## PLANNING COMMISSION STAFF REPORT

SUBJECT: ALEX & JOSHUA IRMBERG FOR A MINOR ARCHITECTURAL APPLICATION ADDING A CARPORT, CASITA AND ASSOCIATED POOL TERRACES AND SHADE TRELLISES AT AN EXISTING SINGLE-FAMILY RESIDENCE ON A HILLSIDE LOT LOCATED AT 3580 ANDREAS HILLS DRIVE, ZONE R-1-C (CASE 3.272 MAA). (KL)

**Irmberg Residence**  
3580 Andreas Hills Drive

**Proposed Site Improvements:**  
New Carport, Gates, Pool, and Casita

**Entry Gate Notes:**

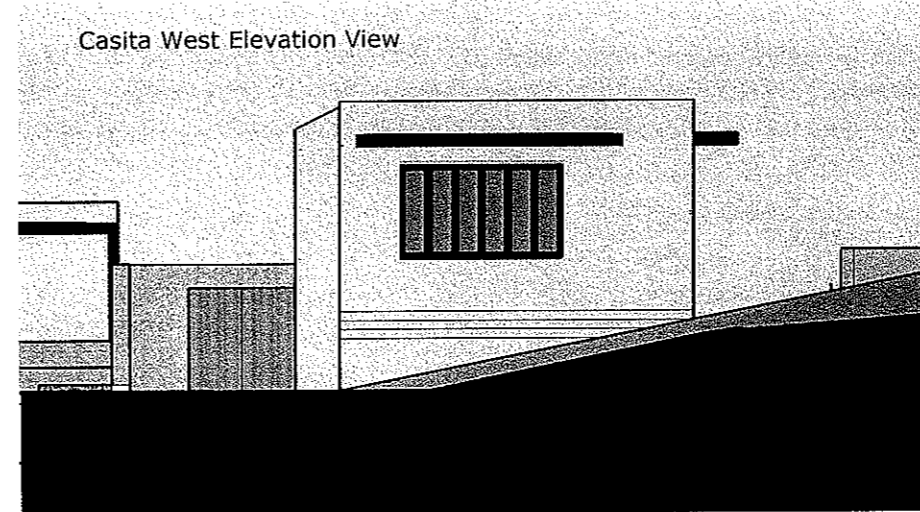
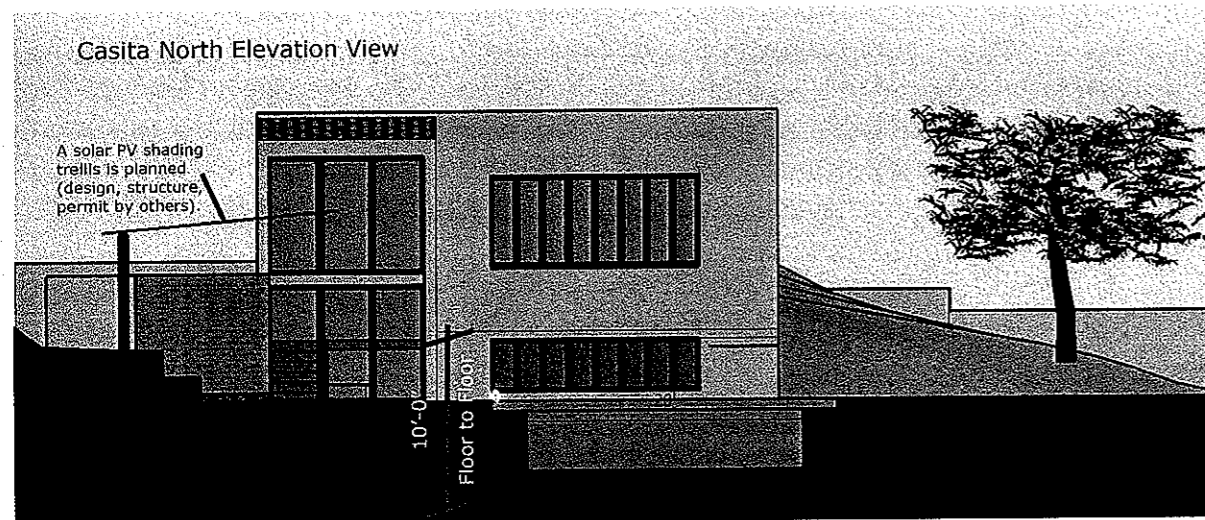
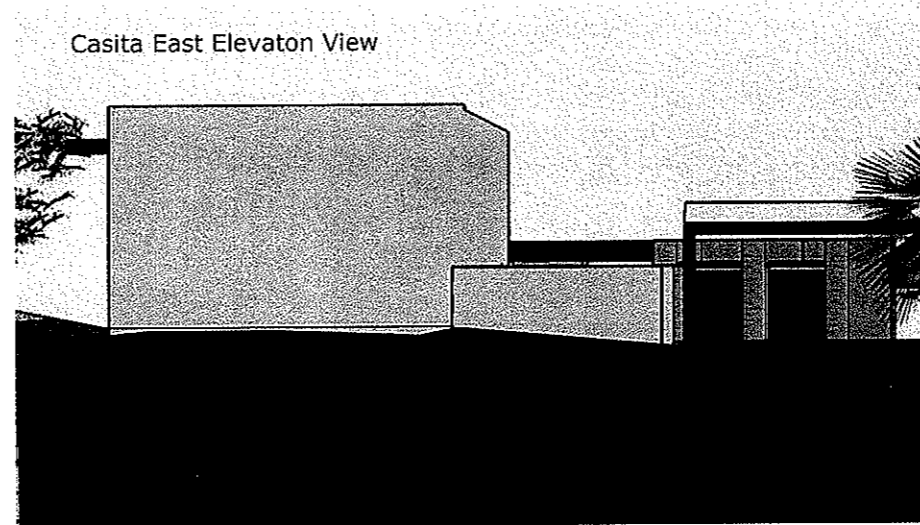
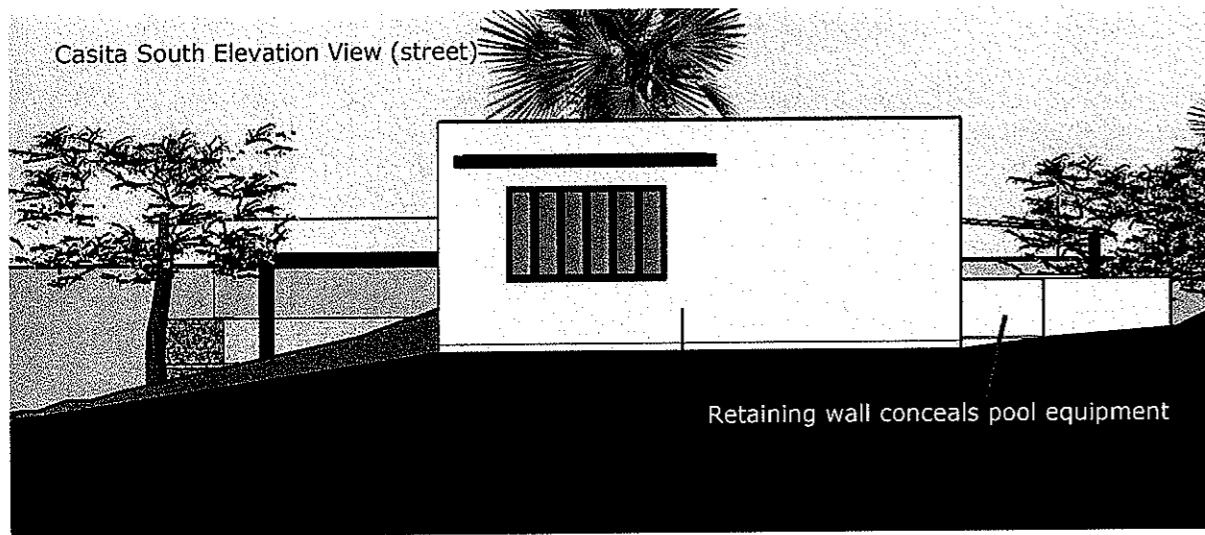
COMMITTEE MEMBER FREDRICKS asked what type of material is the gate.

LYLE BOATMAN, BETTER DESIGN, responded that the gate material will consist of steel frame and wood, Douglas fir, and the pedestrian gate metal clad wood with ribbed glass. They will relocate existing landscaping on site.

CHAIR SECOY-JENSEN stated that Douglas fir is not sturdy in the desert.

COMMITTEE MEMBER FREDRICKS stated that the gate material will not stand up and does not see the detail especially on the landscaping. He said that some existing landscaping will need to be removed and does not want fountain grass. The home at 3670 has a good streetscape.

VICE-CHAIR FAUBER said that round gate and niche do not work. The landscape plan is important and details on trellises are needed.

LYLE BOATMAN, REPRESENTING THE APPLICANT, said he did not change the gate and added photos to show arches.

The existing house is barely visible from the road as the property has a steep rise along the street. The "building pad" is low on the deep lot, relative to the overall existing topography on the hillside site.

Casita Elevation Views Scale: 1/8" = 1'-0"

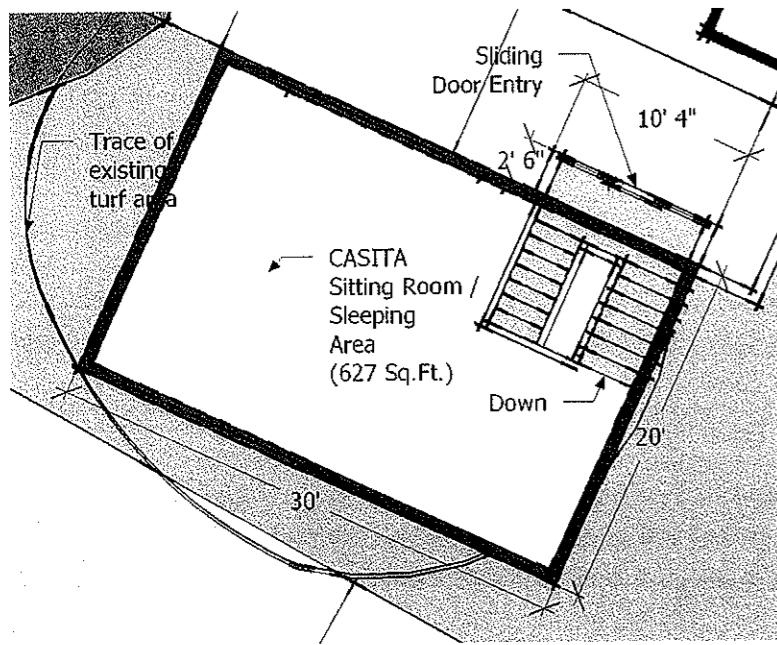
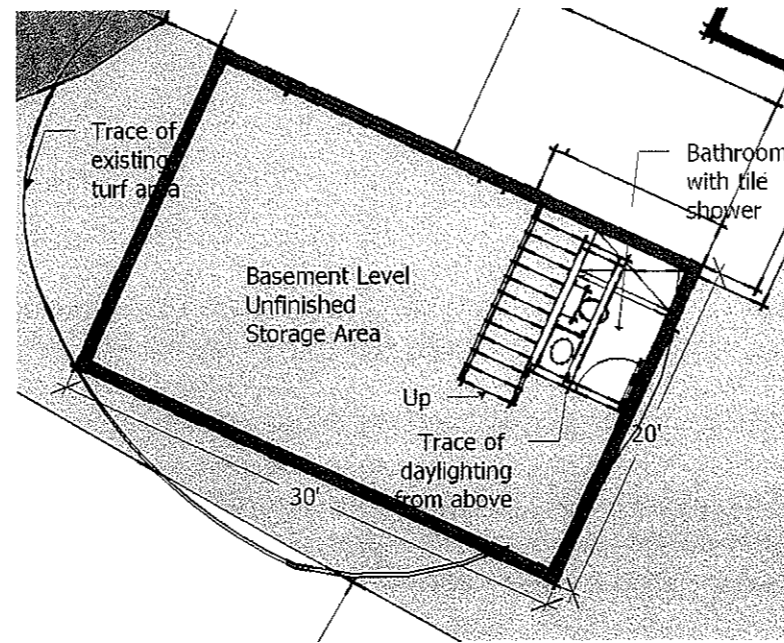
COMMITTEE MEMBER HIRSCHBEIN asked if the casita height meets the code.

VICE-CHAIR FAUBER questioned what the roof material on the guest casita.

ASSOCIATE PLANNER NEWELL responded that the height meets the code requirements.

The tallest facade is the North face, reaching 16' 6 1/2" above the pool deck. This elevation is 13'-6 1/2" above the adjacent property corner at the curb. This height includes a 1'-6 1/2" parapet designed to conceal solar PV panels and HVAC equipment. Building roof is 12' above the elevation at the adjacent lot corner, as measured at the curb.

LANDSCAPE PLAN

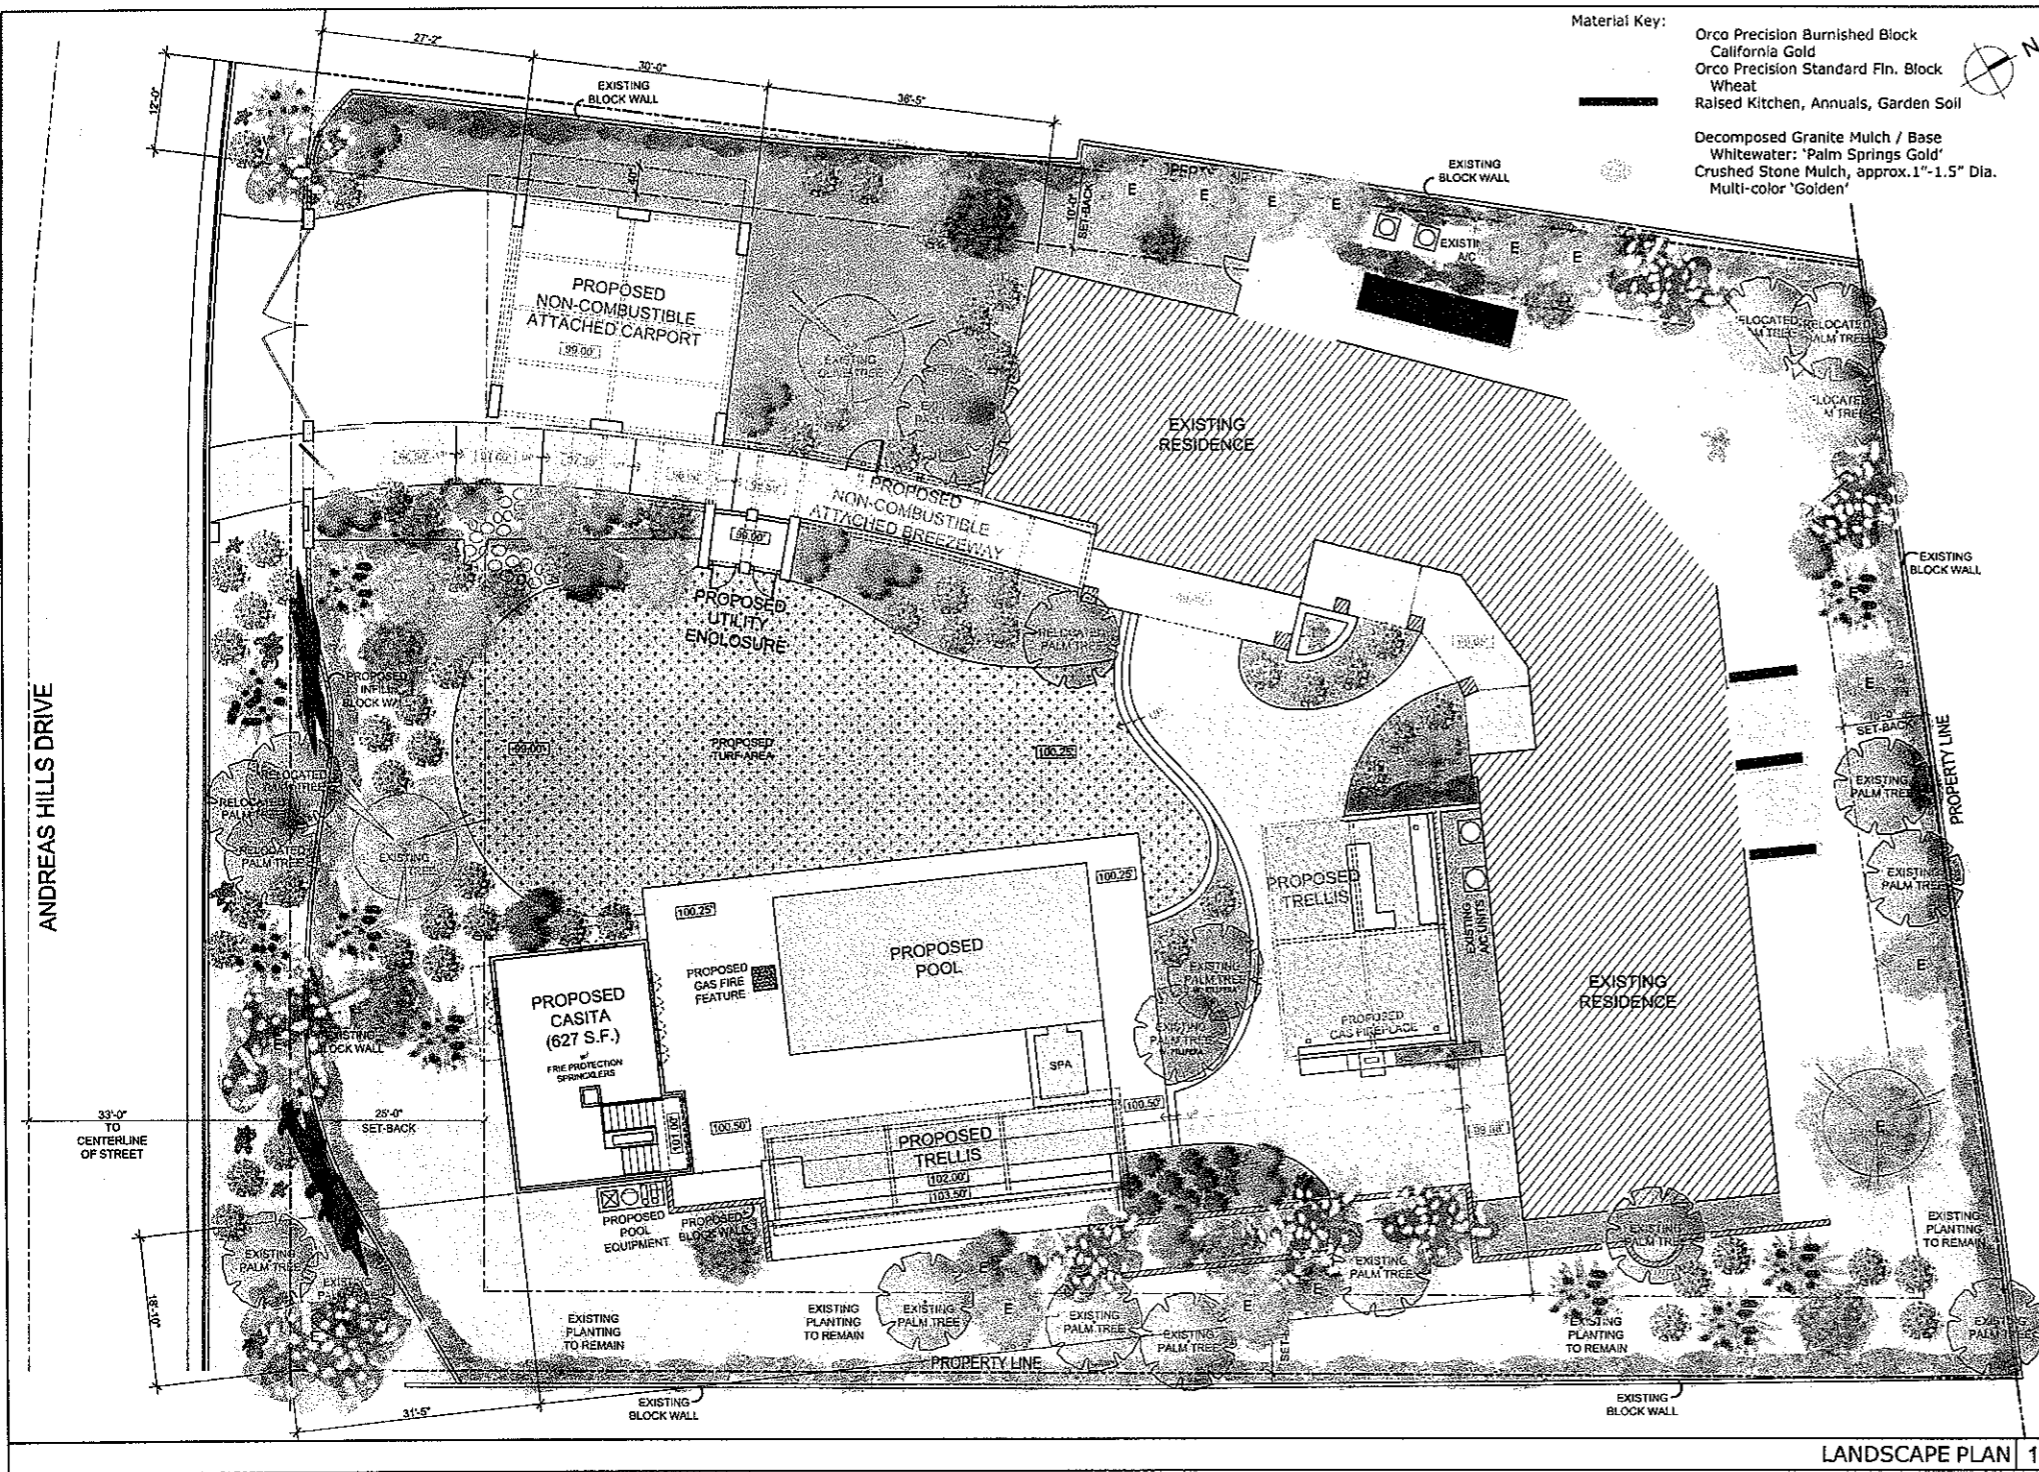
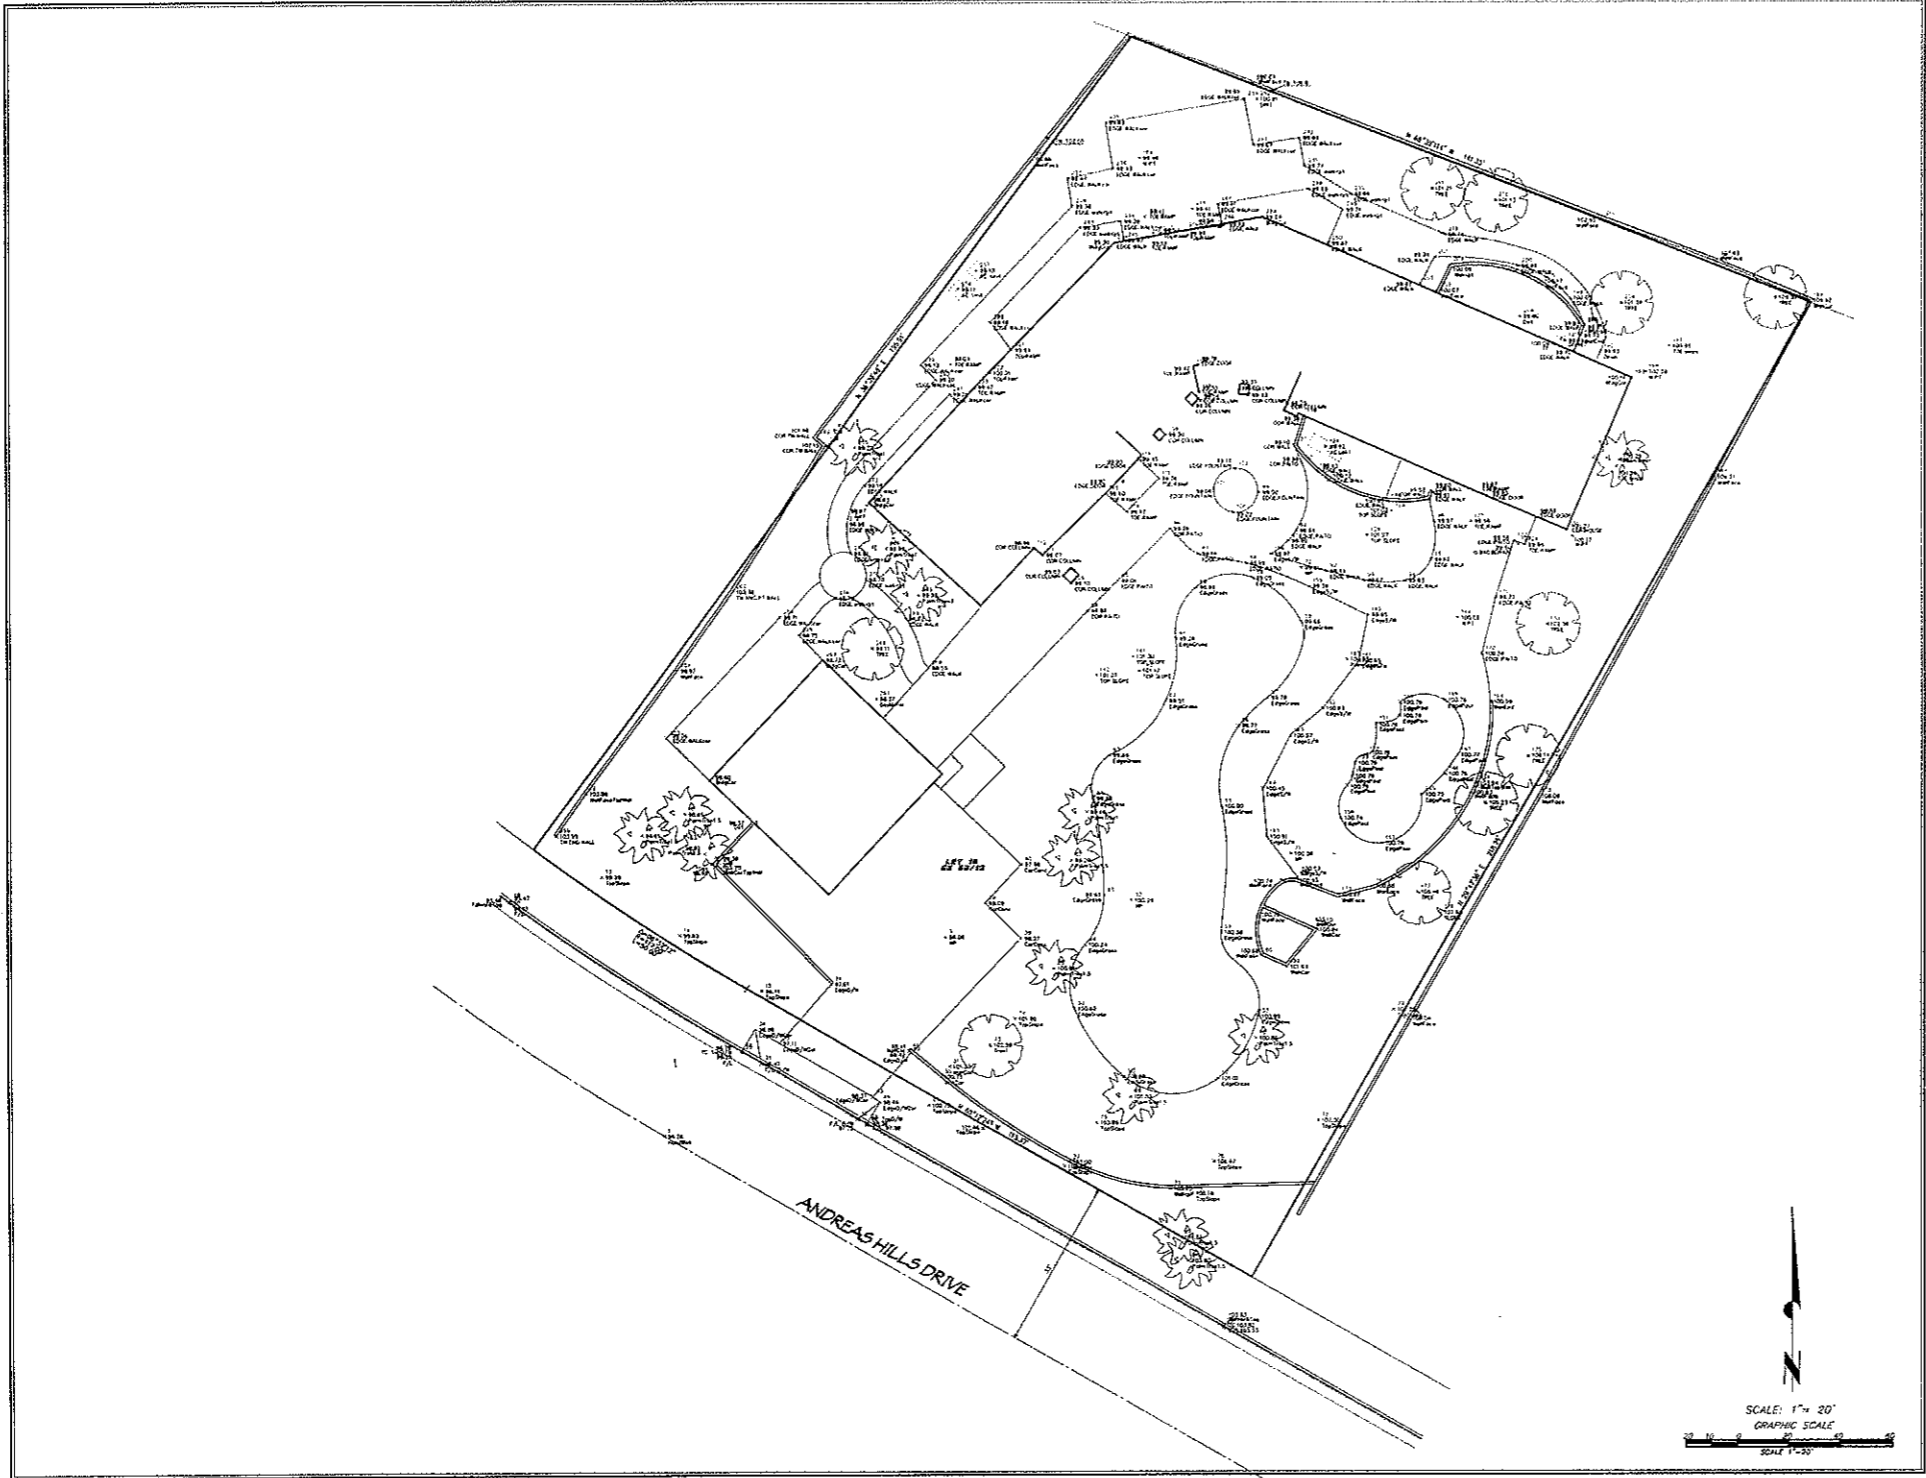
COMMITTEE MEMBER PURNEL said he is struggling to see the interaction of styles and the landscape needs improvement.

COMMITTEE MEMBER FREDRICKS commented that existing trees need trimming and maintenance.

LYLE BOATMAN responded that there will be a new gardener.
